# SERVICE BULLETIN

No. 549

Piper Aircraft Corporation

<u>Subject:</u>	Elevator Bungee Link Modification
<u>Models Affected:</u>	<u>Serial Numbers Affected:</u>
PA-31, PA-31-325 Navajo.....	31-7612001 to 31-7612080 Inclusive; 31-7612082 to 31-7612091 Inclusive; 31-7612096; 31-7612099; 31-7612101; 31-7612102; 31-7612104; 31-7612105; 31-7612107 and 31-7612108.
PA-31-350 Navajo Chieftain.....	31-7652001 to 31-7652015 Inclusive; 31-7652017 to 31-7652162 Inclusive; and 31-7652164 to 31-7652170 Inclusive.

### BUNGEE LINK REWORK DETAIL

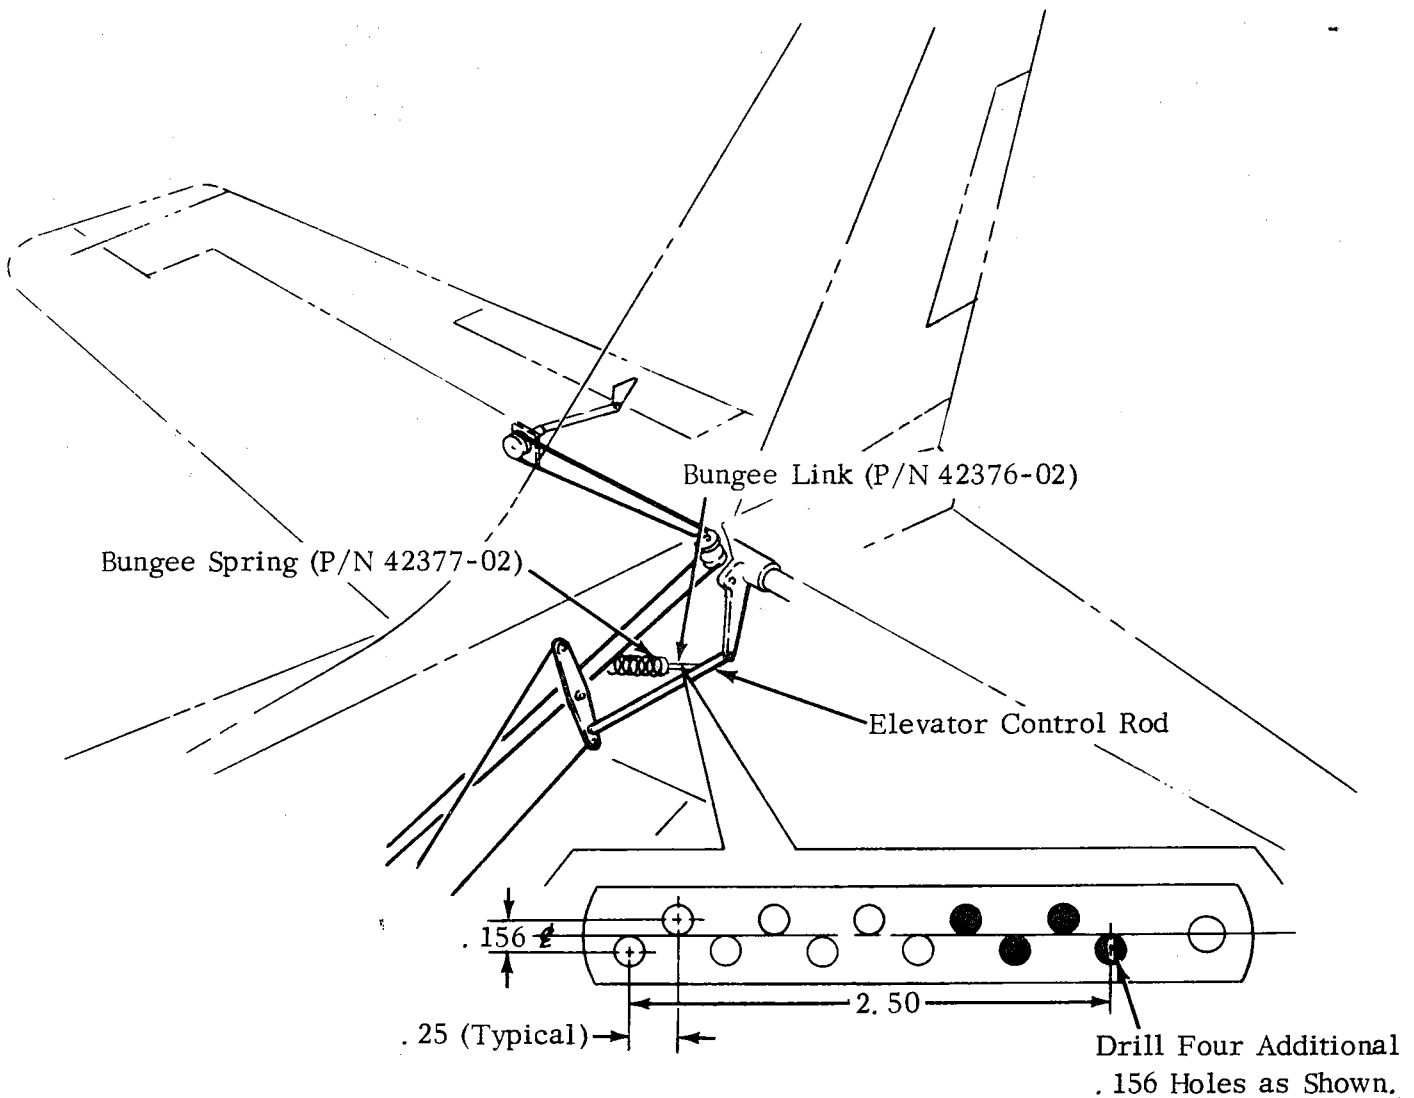
Purpose: During routine factory elevator control rigging/adjustment procedures involving the above referenced aircraft, the specified elevator bungee ("down") spring tension was, in some instances, not obtained due to insufficient adjustment at the elevator bungee link. This condition can be resolved by drilling additional spring attachment/adjustment holes, permitting additional (if necessary) spring tensioning.

This Service Release provides instructions to modify the elevator bungee link by adding spring attachment/adjustment holes (as denoted on attached sketch/instruction data) - if necessary to obtain sufficient elevator bungee spring tension.

1. Remove bottom half of tail cone and side access plate from aft fuselage to gain access to elevator bungee spring and link.
2. Disconnect the bungee spring from the link and remove hardware attaching the link to the elevator control rod.
3. Rework the bungee link by locating and drilling four additional .156 holes as shown in above detail.
4. Reinstall link to control rod using existing hardware.
5. Connect a spring scale to the aft end of the bungee spring and pull rearward until proper tension is obtained with the elevator in the neutral position.

Proper tension for PA-31 is 30 lbs.  $\pm$  1 lb.

Proper tension for PA-31-325 & PA-31-350 is 37 lbs. + 1 - 0 lbs.

At this point, observe which hole in the link is in line with the hook at the end of the spring and connect the spring into this hole. If necessary, cut off excess link material (.188 min. edge distance) for ease of spring attachment. (Reference "Rigging and Adjustment of Elevator Controls" in appropriate Service Manual.)
